Stage 03: Workgroup Report

Connection and Use of System Code (CUSC)

CMP261

‘Ensuring the TNUoS paid by Generators in GB in Charging Year 2015/16 is in compliance with the €2.5/MWh annual average limit set in EU Regulation 838/2010 Part B (3)’

Figure 3: Graph showing the Daily Bank of England €/£ Exchange Rate for 2015/16 and the forecast rate used in tariff setting for 2015/16

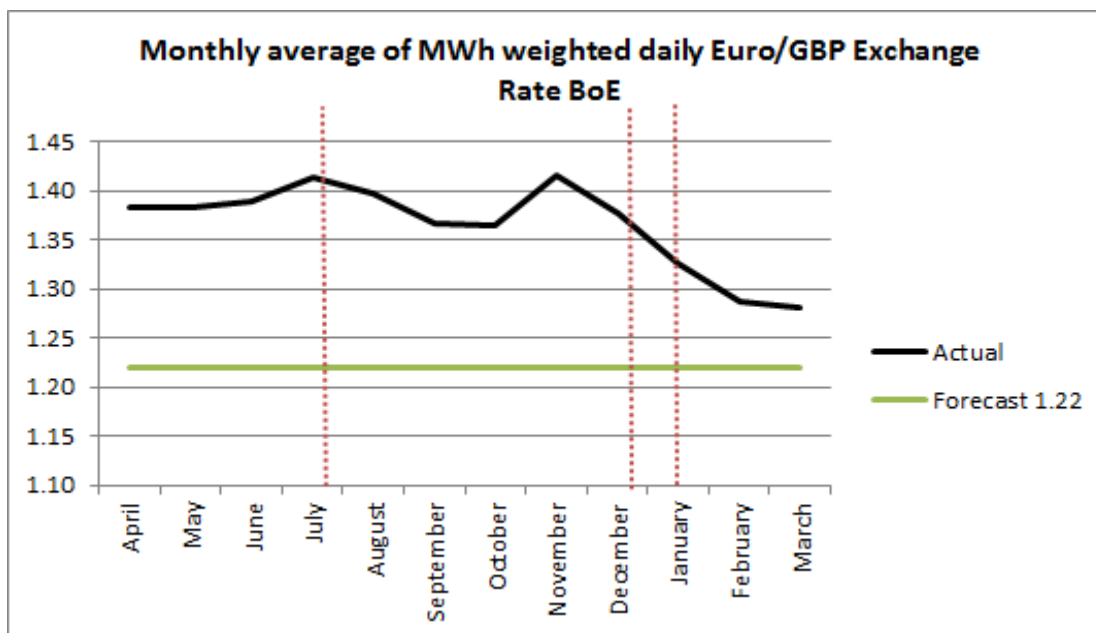
2.41 The Proposer argued that due to higher than necessary generation TNUoS charges electricity wholesale costs could have had a negative impact on consumers, cross border trade, competition and interconnectors could have financially benefited due to increased flows.

Figure 7 : Possible Ex Post Reconciliation Options

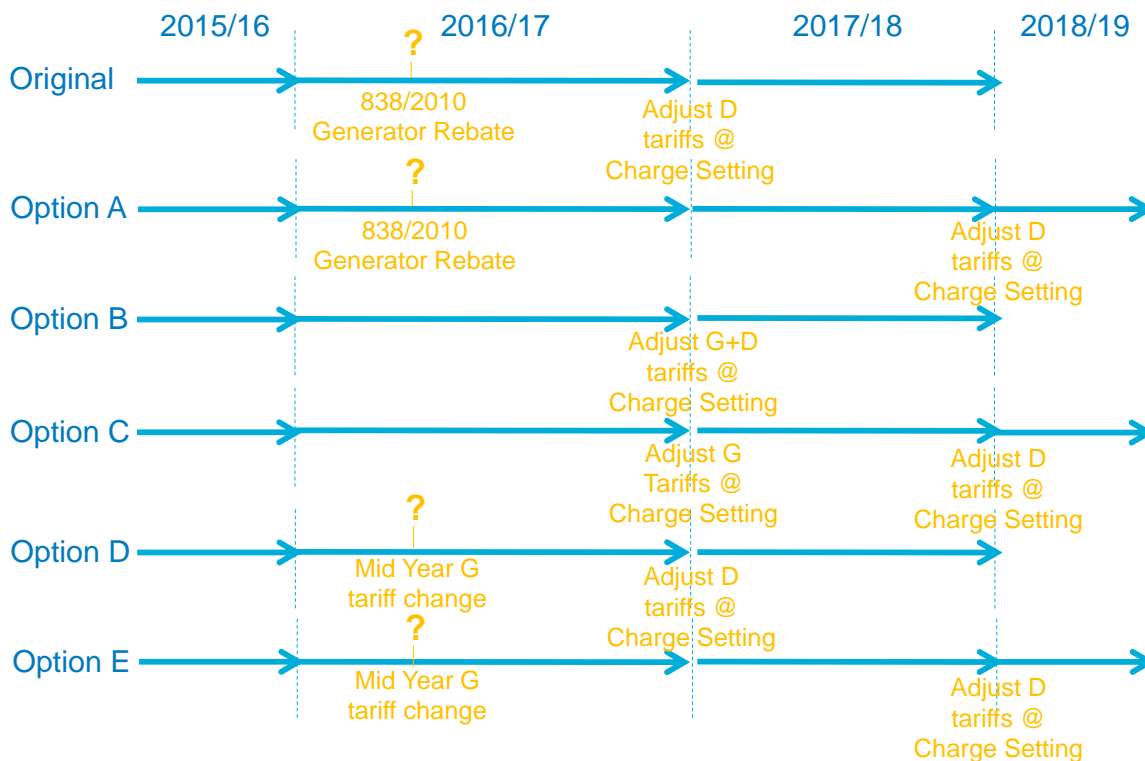
- 4.2 The Workgroup initially identified five possible reconciliation options (A to E) in addition to the Original approach to a possible reconciliation. A further option (F) was identified after the Workgroup Consultation stage.

- 4.3 The **Original** proposes a rebate (as opposed to a Generator TNUoS tariff change in a future – non 2015/16 – Charging Year) to all those Generators holding Transmission Entry Capacity in Charging Year 2015/16 as soon as possible following a decision by Ofgem to approve the Original, with the value of the reconciliation amount paid to Generators being recovered from Suppliers by an adjustment to Demand TNUoS tariffs in the Charging Year 2017/18.

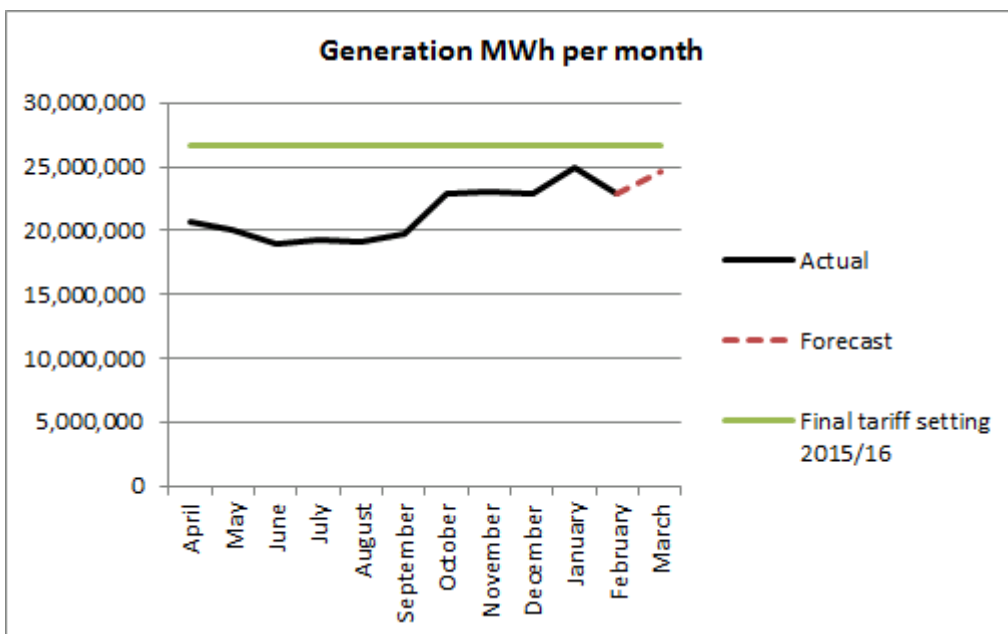
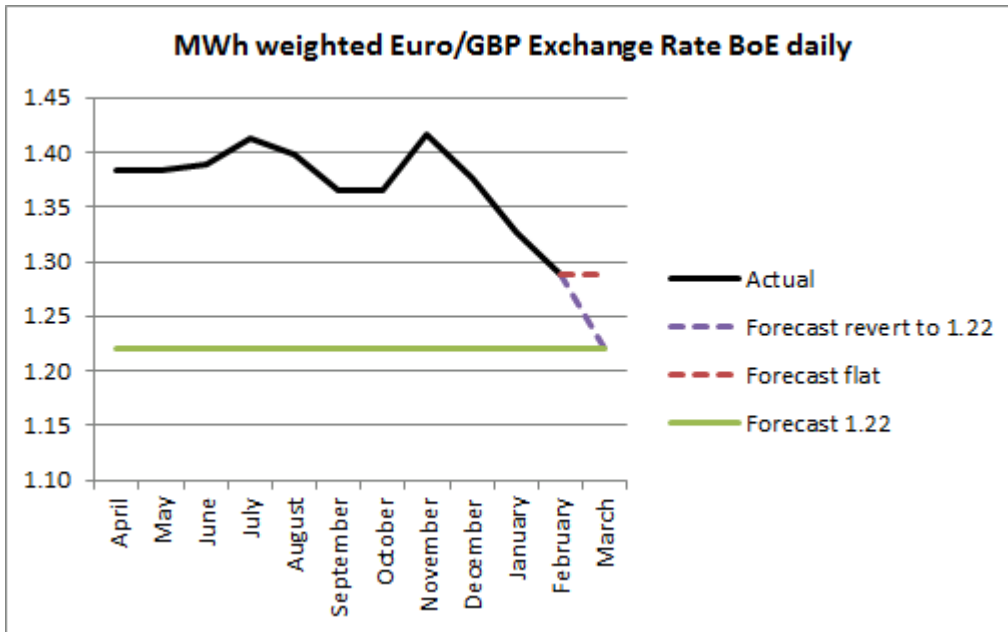
The following two graphs illustrate these deviations. As can clearly be seen, at no point from the 1st April 2015 to 29th February 2016 have either of the two variables reached the levels forecast in January 2015 (when the charges for 2015/16 were set).

If this defect is not corrected, it will result in an exceedance of the upper limit set in EU Regulation 838/2010 Part B (paragraph 3) of €2.50/MWh for the average annual amount to be recovered from generators in Great Britain in charging year 2015/16.

Our indicative estimate, based on publically available information (as at the end of February) is that this exceedance could result in the average annual TNUoS charges paid by generators in GB, in charging year 2015/16, amounting to circa €3.25 /MWh, which is approximately
